Office of Ratepayer Advocates  
California Public Utilities Commission

May 17, 2018

**Subject: Office of Ratepayer Advocates Comments on the Draft Subsequent Environmental Impact Report (DSEIR), SCH Nos. 200701113, Regarding 230 kiloVolt (kV) Substation Options for the Riverside Transmission Reliability Project. Application (A.) 15-04-013.**

**Figure 1 – Alternative 26**

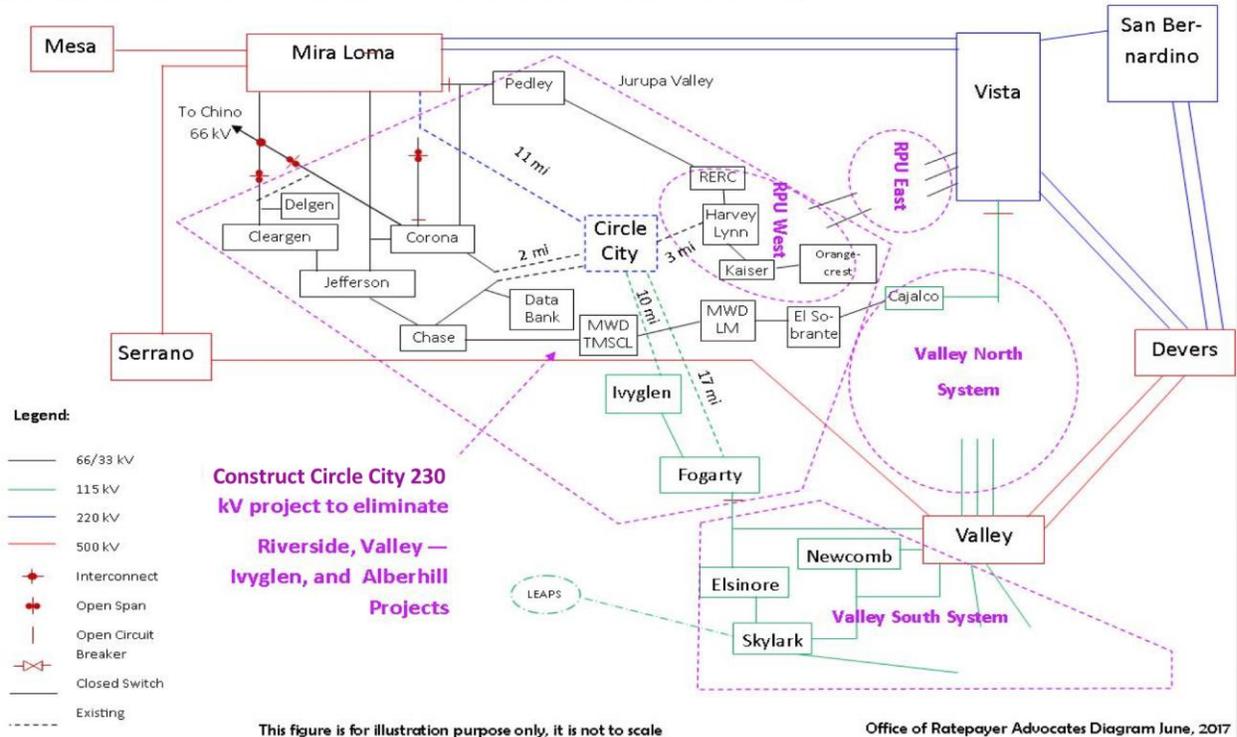
The DSEIR evaluated thirty alternative projects<sup>1</sup> to SCE's Proposed Project,<sup>2</sup> including ORA's proposed Alternative 26.<sup>3</sup> (See Figure 1) Alternative 26 involves modifying SCE's proposed 66 kiloVolt (kV) Circle City Substation Project and constructing new 115 kV and 230 kV transmission lines to replace a number of SCE projects.<sup>4</sup> This alternative would construct the Circle City Substation as a 230/115/66 kV Substation, and interconnect it to the Mira Loma Substation in the City of Ontario, with approximately 11 miles of 230 kV lines, using existing and some new rights of way (ROW). Approximately 27 (17 +10) miles<sup>5</sup> of 115 kV line along I-15 freeway would be constructed to connect Ivyglen and Fogarty 115 kV Substations to the new Circle City 230 kV Substation. The Circle City Substation would then supply power to the Corona, Pedley, Data Bank, Chase, Jefferson, Cleargen,

The DSEIR concludes that Alternative 26 should be rejected because Alternative 26 does not meet the basic project objectives, does not meet the regulatory feasibility criteria, and does not reduce environmental impacts.<sup>7</sup>

**Figure 2 – Modified Alternative 26**

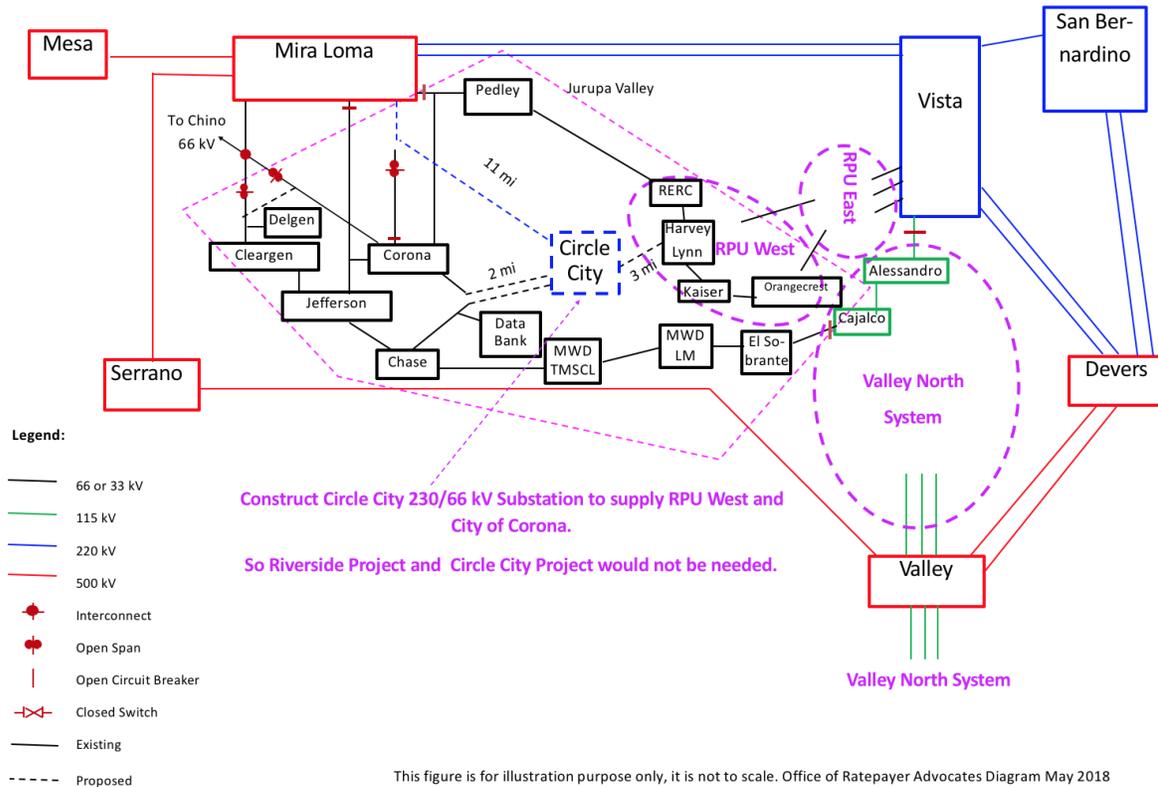
Based on this new information, Alternative 26 should be modified ( Modified Alternative 26)<sup>8</sup> to eliminate the need to construct the 27 mile 115kV transmission line. (See Figure 2) ORA's Modified Alternative 26 would construct the Circle City Substation as a 230/66 kV Substation instead of constructing SCE's proposed 66 kV Substation. The Circle City Substation would interconnect to the Mira Loma Substation, which is in the City of Ontario, with approximately 11 miles of 230 kV transmission lines. Then the Circle City Substation would connect to Riverside with a 66 kV transmission lines to serve the RPU's load.

ORA recommends that Modified Alternative 26 be evaluated in the Final Subsequent Environmental Impact Report (FSEIR) to consider the potential approval of Valley-Ivyglen Substation. Modified Alternative 26 meets the basic project objectives, meets the regulatory feasibility criteria, and reduces environmental impacts as discussed below. In addition, ORA recommends the Commission evaluate another bulk transmission alternative (Proposed Bulk Transmission Alternative, see Figure 3) in the FSEIR as discussed below.

ORA's proposed Modified Alternative 26 meets all of SCE's proposed project objectives, and also would result in less cost and less environmental impact by eliminating the construction of two substations: SCE's Proposed 230 kV Wildlife Substation in the City of Riverside and the RPU's 66 kV Wilderness Substation in the RPU service area. Therefore, the Modified Alternative 26 should be compared to the DSEIR's Alternatives 1 – 4 in the FSEIR.

The Modified Alternative 26’s 230 kV high voltage line route should not have any permitting limitations. In fact, the line route may have fewer environmental impacts compared to the proposed project. For example, there is no need to build two substations (one for the SCE’s 230 kV line and one for the RPU’s 66 kV lines). Also, construction of the Modified Alternative 26, may not impact lands with legal protection along the transmission route. In addition, the Modified Alternative 26 is consistent with regulatory standards and uses the same technology as the DSEIR’s Alternatives 1-4. In fact, a major part of the Modified Alternative 26’s 230 kV lines follow SCE’s proposed 230 kV Substation siting and routing,

Figure 3 – Proposed Bulk Transmission Alternative

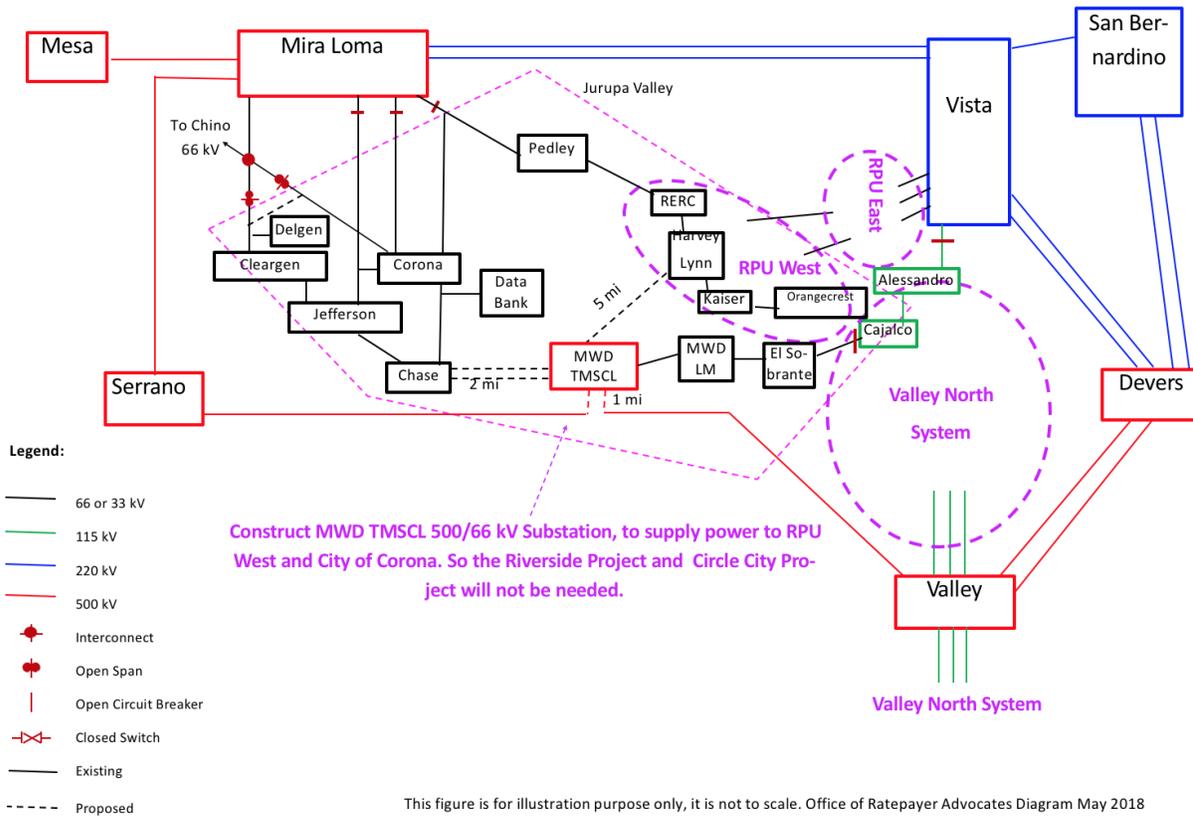
ORA also recommends that the FSEIR evaluate the construction of a new 500 kV Substation to be located at the Metropolitan Water District Substation at Temescal Canyon (MWD-TMSCL). The new 500 kV Substation at MWD-TMSCL would connect to SCE's existing 500 kV Serrano to Valley transmission line and also would connect to RPU's Harvey Lynn 66kV Substation. (See Figure 3) This bulk transmission alternative would: 1) meet all of the project objectives of a bulk transmission resource for SCE and RPU; 2) eliminate the construction of SCE's proposed 230 kV Wildlife Substation and the RPU's 66 kV Wilderness Substation; 3) eliminate all 230 kV underground routings that are recommended in the DSEIR's Alternatives 1–4; 4) cost significantly less than the Proposed Project and Alternatives 1-4; and 5) cause fewer environmental impacts than the Proposed Project. Additionally, this alternative would further reduce the bulk transmission route to about a mile

of 500 kV transmission line to connect with the Serrano/Valley 500 kV transmission line (See Figure 3), while the four alternatives analyzed in the DSEIR and Modified Alternative 26 require 10 – 11 miles of 230 kV transmission lines. In addition to meeting all of the RTRP bulk transmission system objectives, the bulk transmission alternative would cost significantly less and have fewer environmental impacts compared to SCE’s Proposed Project and Alternatives 1-4. Therefore, the Commission should conduct a full environmental review on this alternative in the FSEIR and compare it to the four screened alternatives and Modified Alternative 26.
